Access Compliance Report Public Rights-of-Way (Pedestrian Signals)

Main Street: **ORANGE_AVE** Cross Street: **GILBERT_ST** Location: **NE**

ADA ID: **SGRK210927113649** Signal Type: **One Push Button-Non APS** Overall Compliance: **No** Severity Scores: **BTN 1: 35** **BTN 2: N/A** **No BTN: N/A**

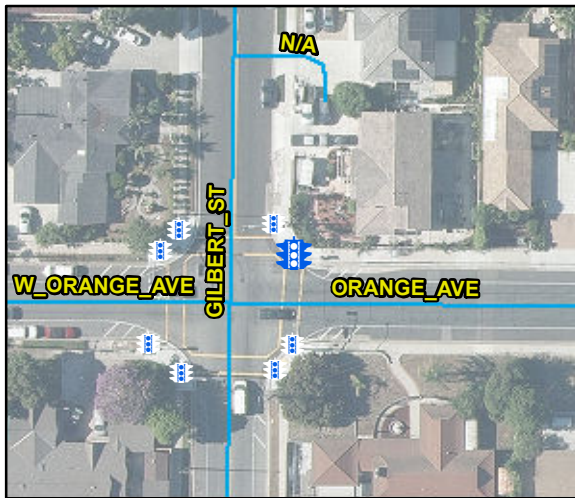
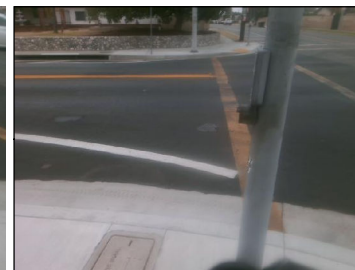
OC Std/PROW: **R404.2, DMS-11132, R104.2, R209.1, MUTCD 4e.08**

Possible Solutions: Replace Signal Push Button With APS Button. Remove and Replace Clear Space.
